UNITED STATES PATENT AND TRADEMARK OFFICE

10/728,248

Office Action Summary	Application No. 10/728,248	Applicant(s) DICARLO ET AL.	
	Examiner RENE TOWA	Art Unit 3736

DETAILED ACTION

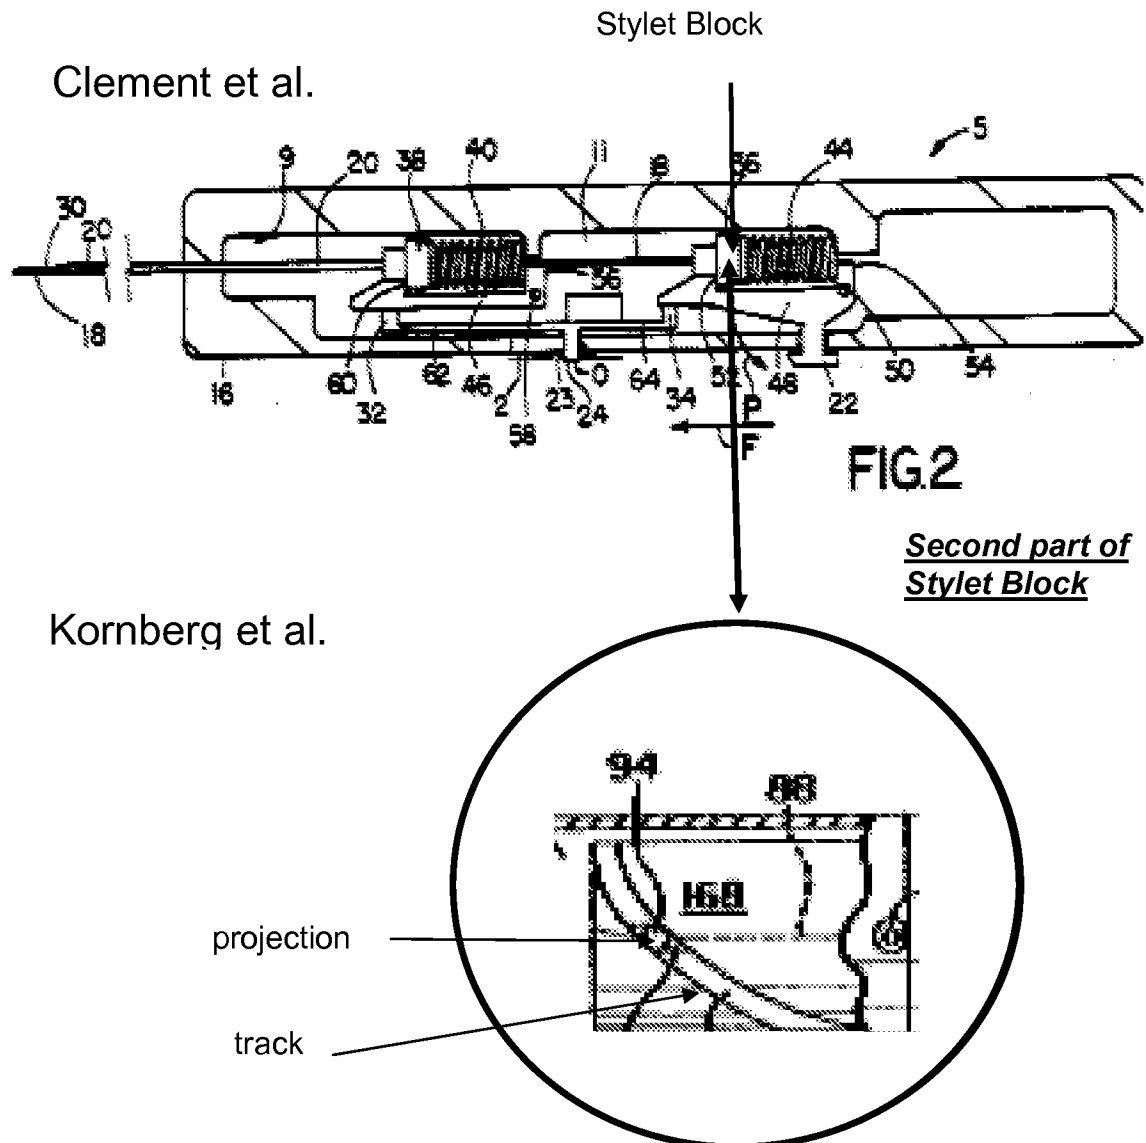
8. Applicant's arguments filed January 27, 2009 have been fully considered but they are not persuasive. Applicant contends that the prior art fails to teach a second part. This argument has been considered but has not been deemed persuasive.

In response to the Applicant's argument, the Examiner respectfully traverses. The Examiner notes that Clement et al. teach an instrument as described in the rejection supra and reproduced below to facilitate the Applicant's understanding of the Office action.

To the contrary, the Office action dated November 4, 2008, which supersedes all previous communications, asserts in part that Clement et al. teach **a stylet block 36** at page 2 while at page 4, the Office action states that Kornberg et al. disclose a biopsy medical system including **a second part** "having a projection 94 in contact with a track 158 associated with a housing 70; wherein the track 158 is configured to provide unidirectional rotation to the cannula 54; wherein the track is configured to provide multidirectional rotation to the cannula 54 (see figs. 9,12,17 & 28; column 2/lines 1-9; column 3/lines 39-50 & 52-66; column 4/lines 29-31, 39-42 & 49-61; column 8/lines 18-23 & 25-32; column 9/lines 25-40 & 53-61; column 10/lines 3-6 & 19-24; column 11/lines 27-34 & 46-53; column 12/lines 2-5, 25-32 & 40-47; column 13/lines 19-25; column 14/lines 26-34 & 45-47)." As such, the Examiner submits that Clement et al. fully teach a stylet block and Kornberg et al. fully teach a second part comprising a projection and track.

In view of the foregoing, the rejections over at least one of Clement et al., Kornberg et al. and Sher are maintained.
